ADDENDUM
NO. 3

April 17, 2026

**TRI-TOWNSHIP WANATAH SCHOOL
RENOVATION AND RELATED WORK
Wanatah, IN 46390**

This Addendum consists of Pages ADD 3-1 through ADD 3-4, and attached Addendum No. 3 from Gibraltar Design dated April 16, 2026 and consisting of 5 pages, replacement Specification Section 33 40 00 - Storm Sewage Systems, and 15 drawings.

A-110

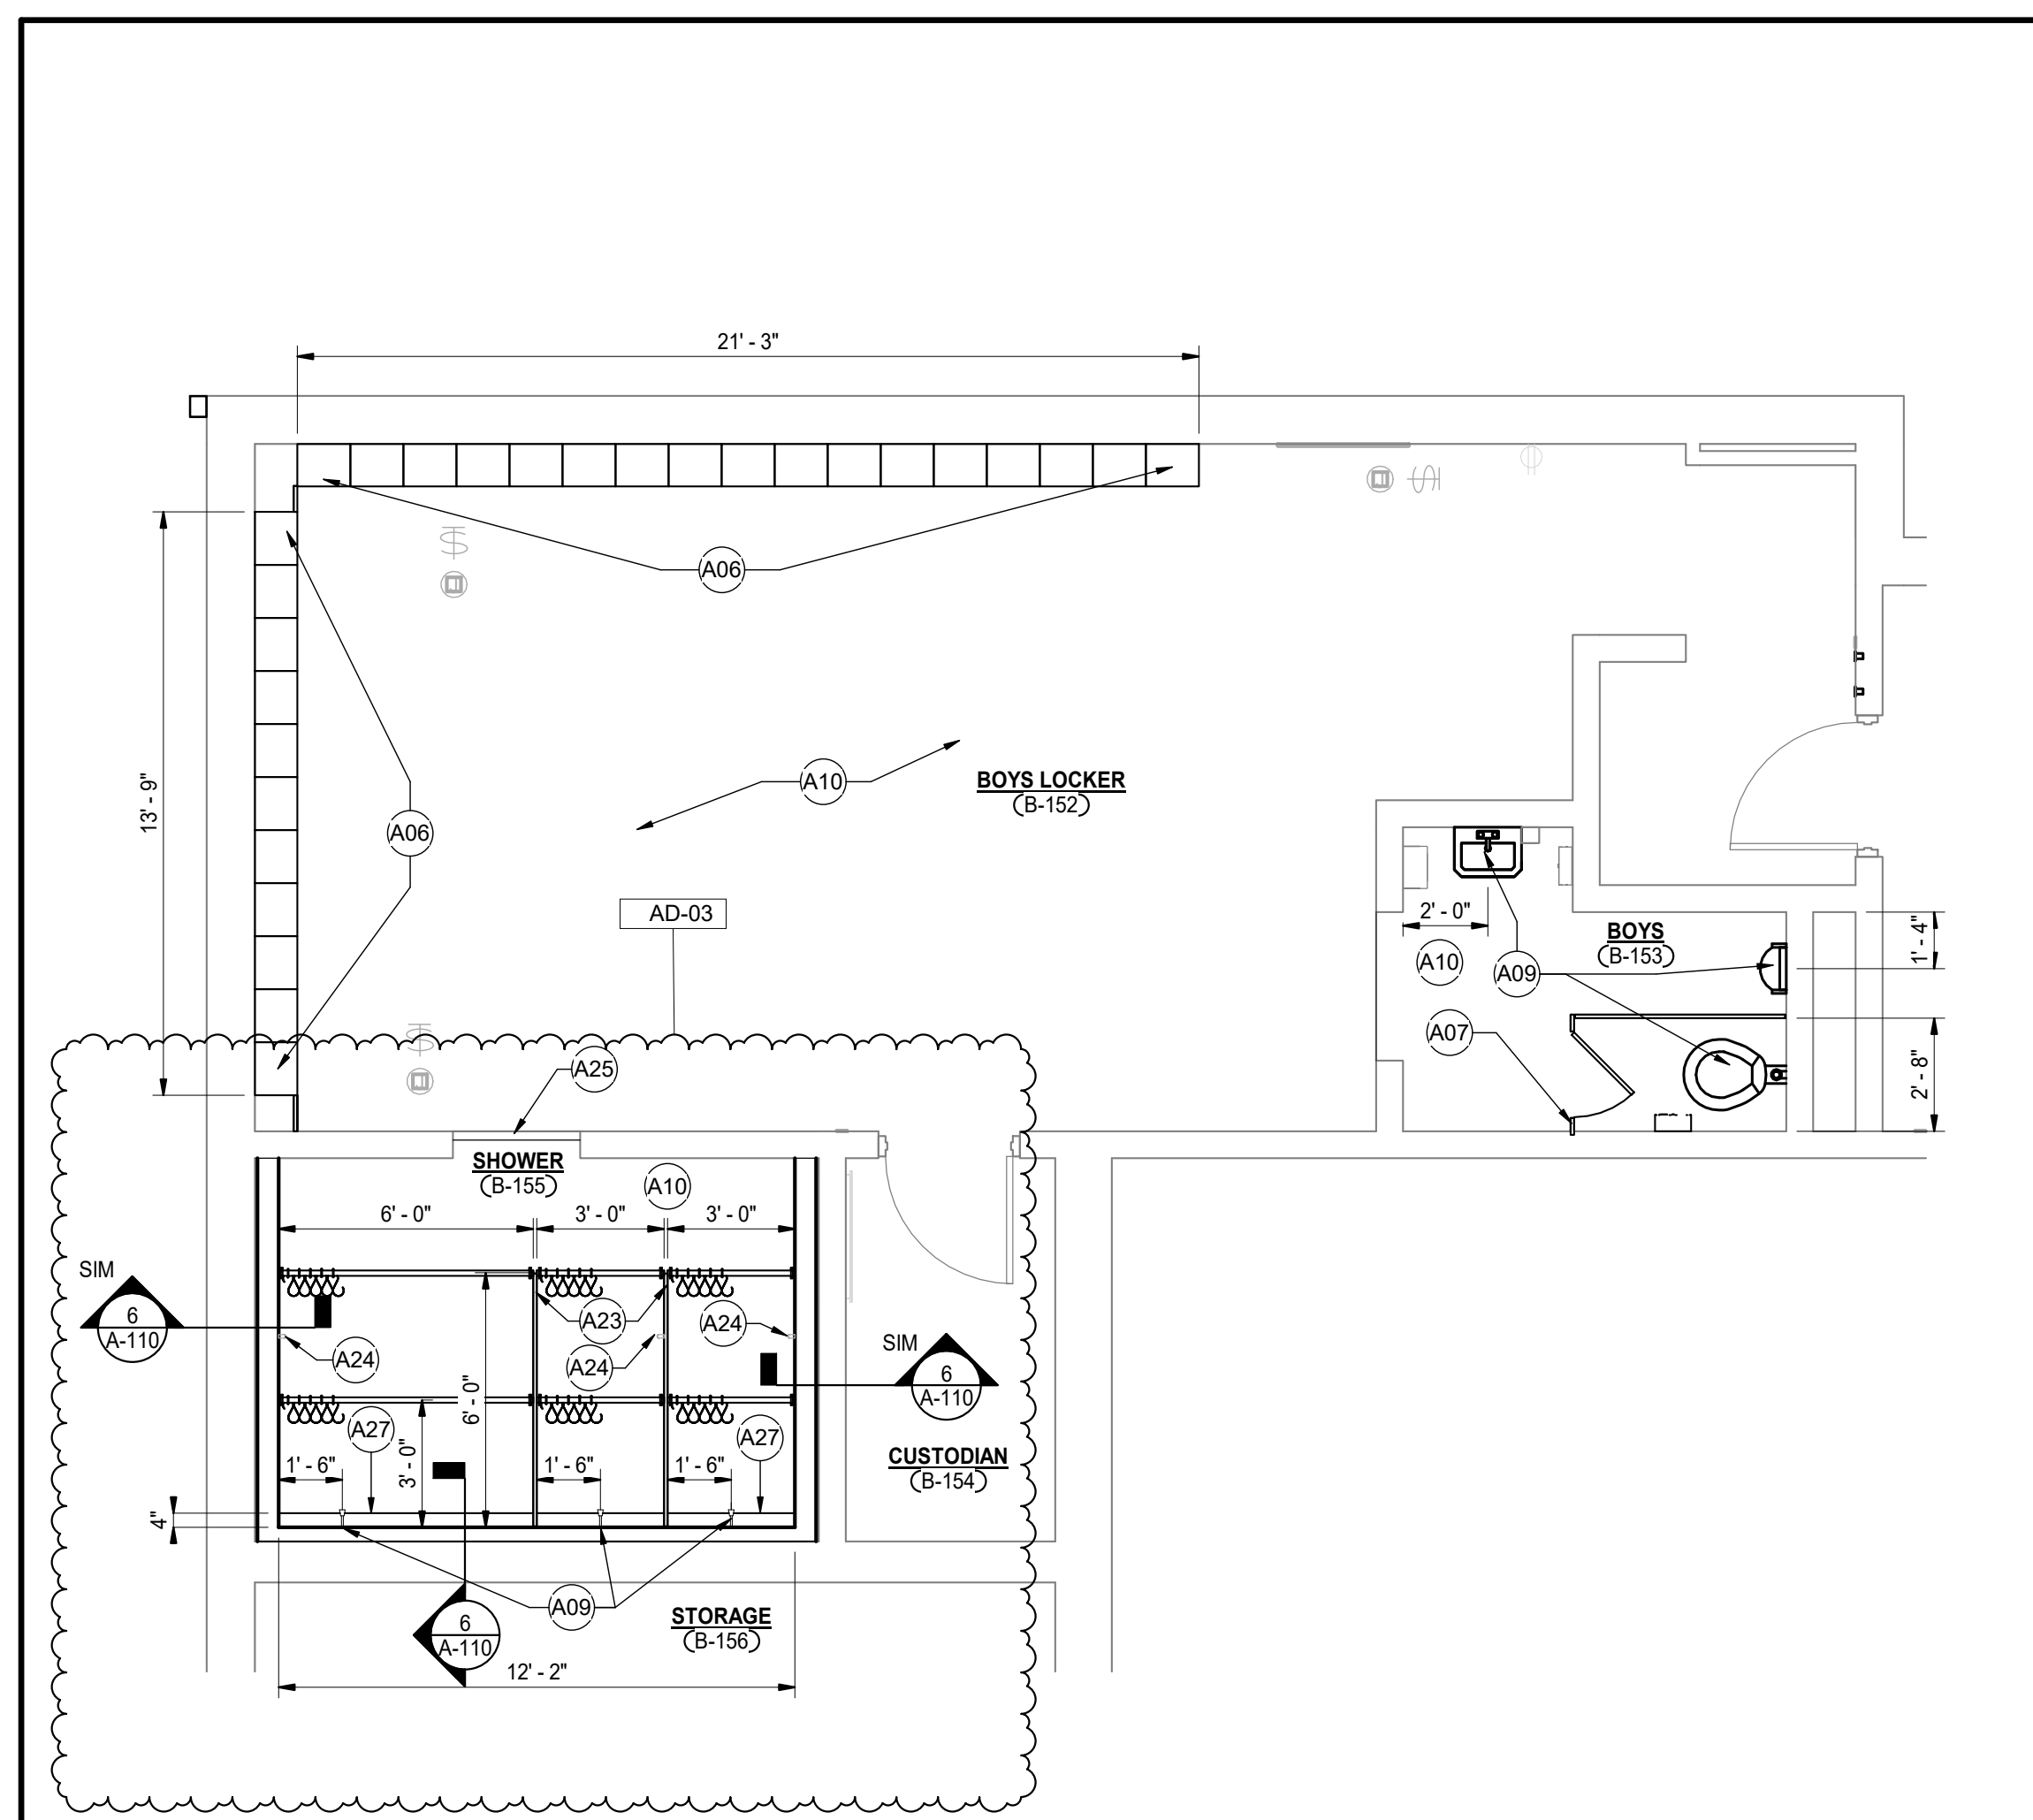
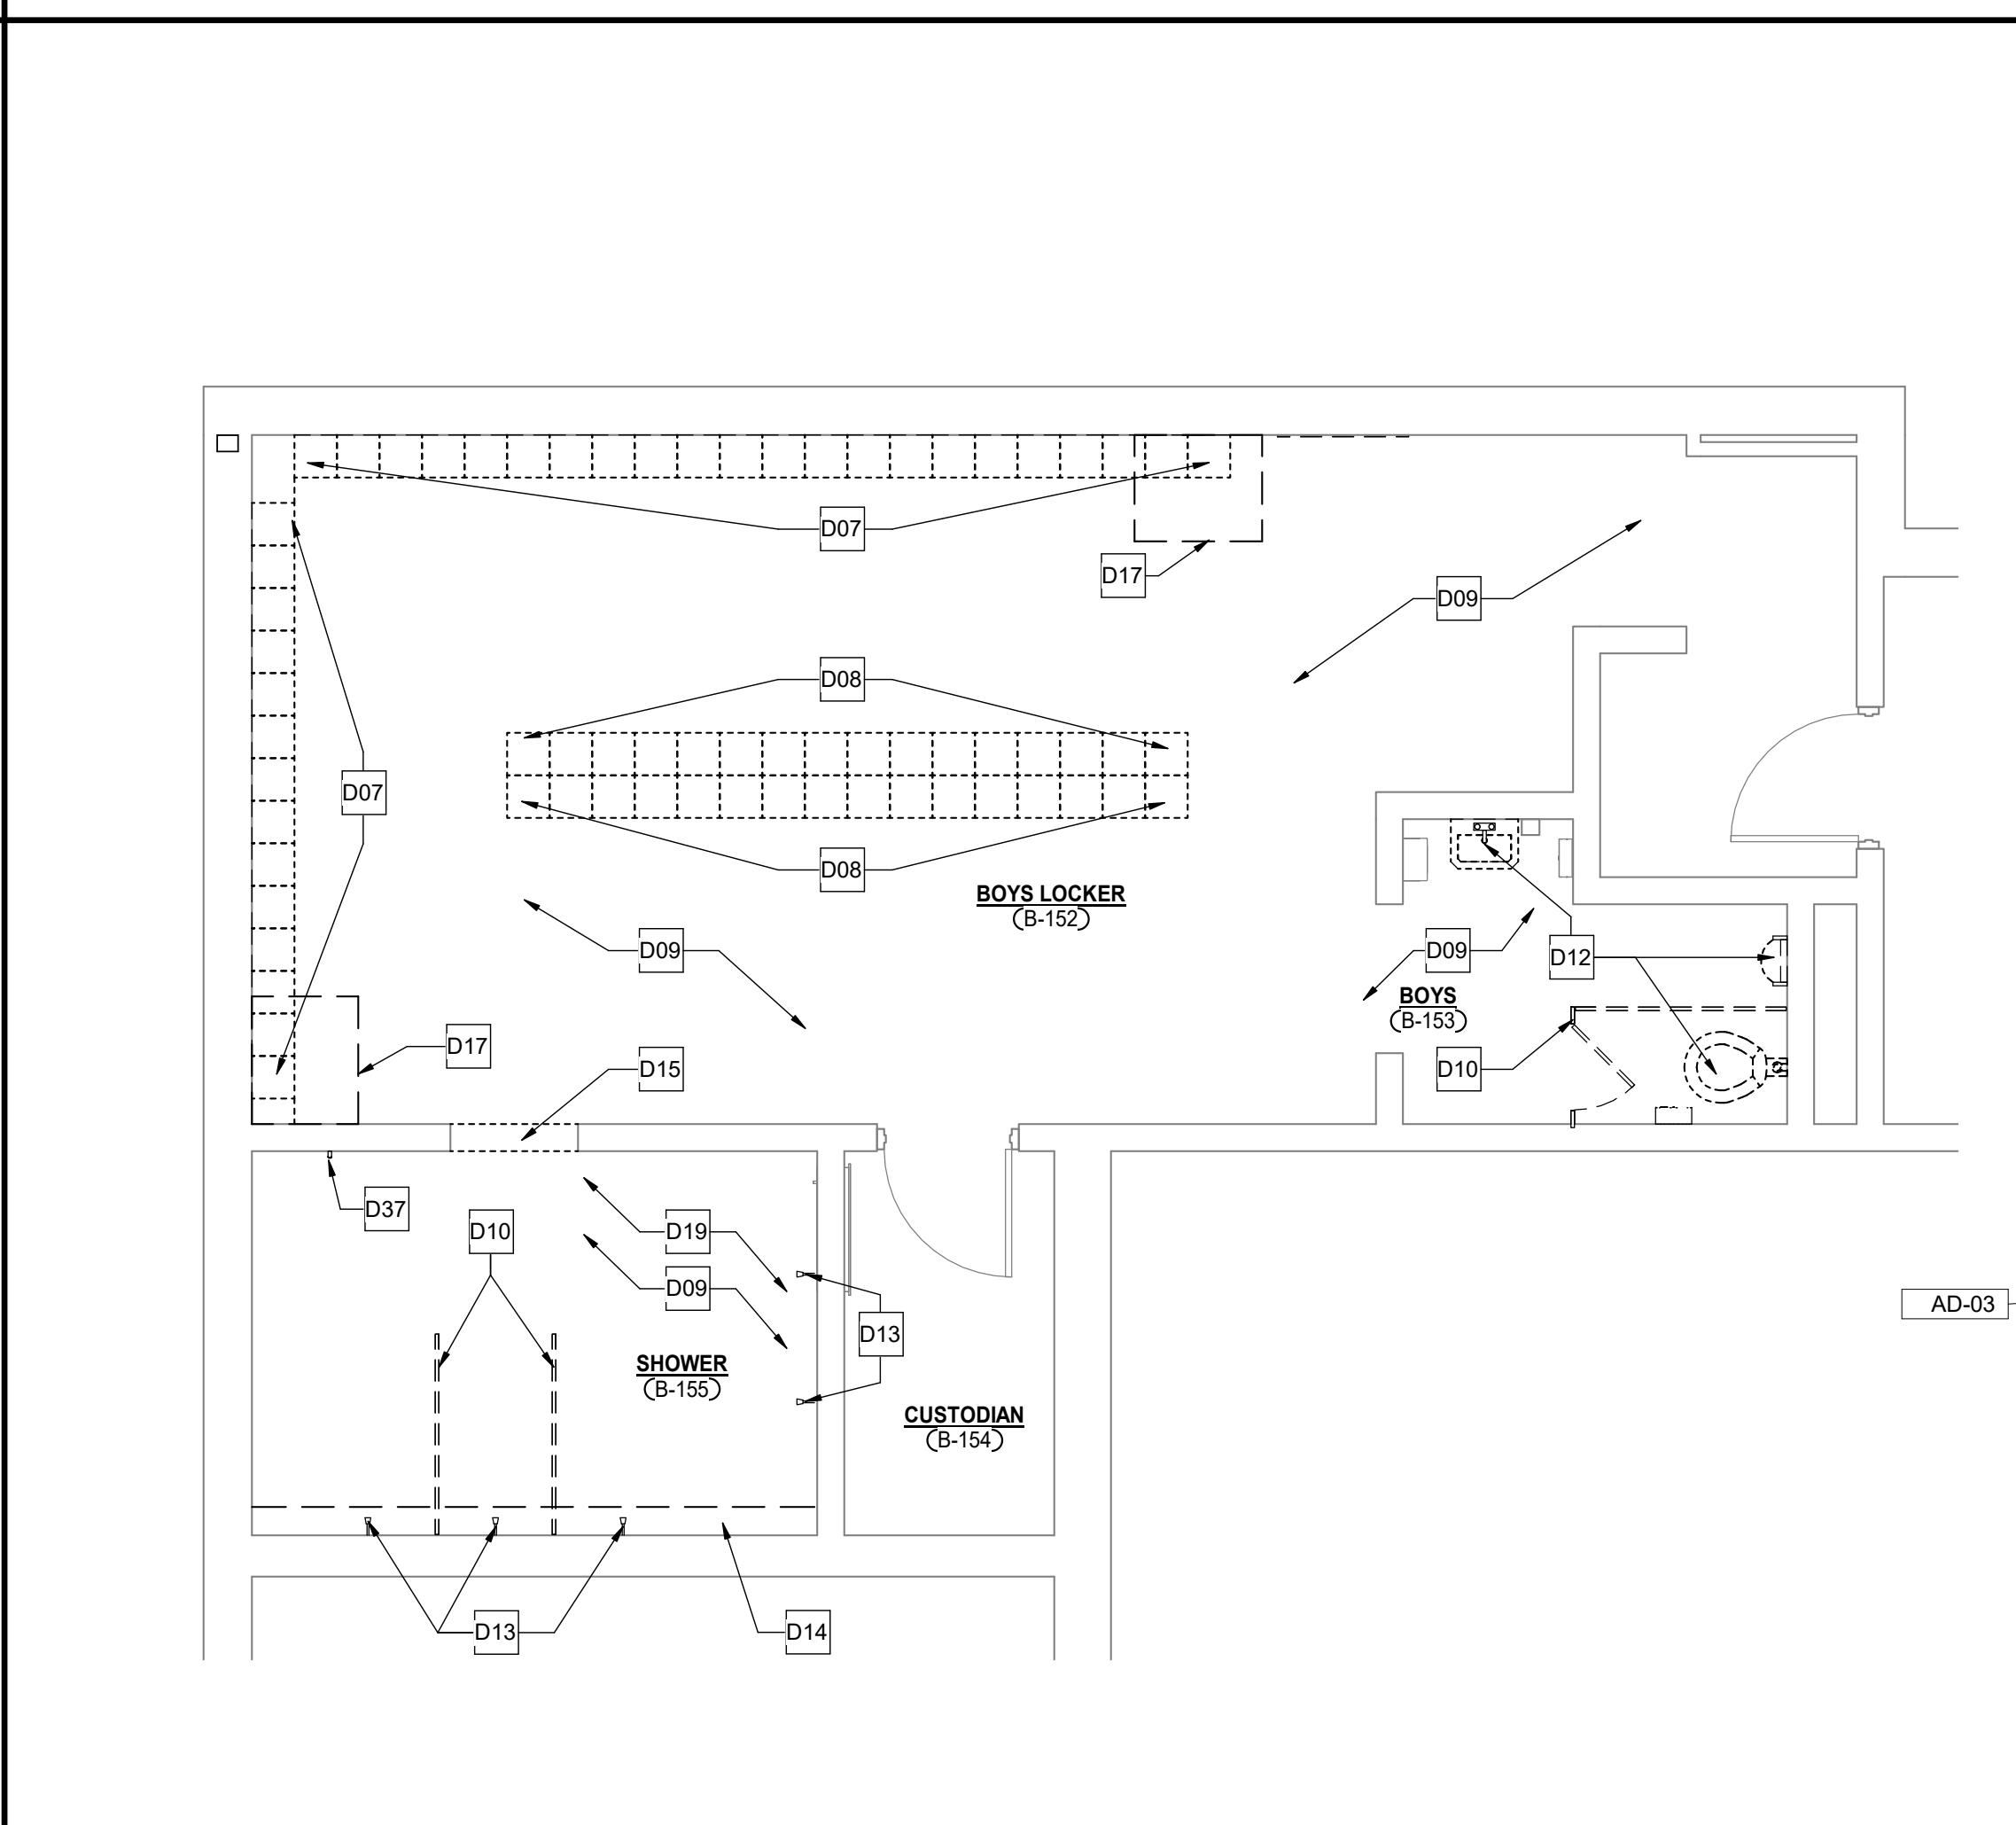
17. Sheet A-110

- A. Refer to revised, full-size drawing, for clarifications to wall framing, trench drain, and wall section detail for Shower Rooms B-146 and B-155, included in this Addendum, for clarifications.
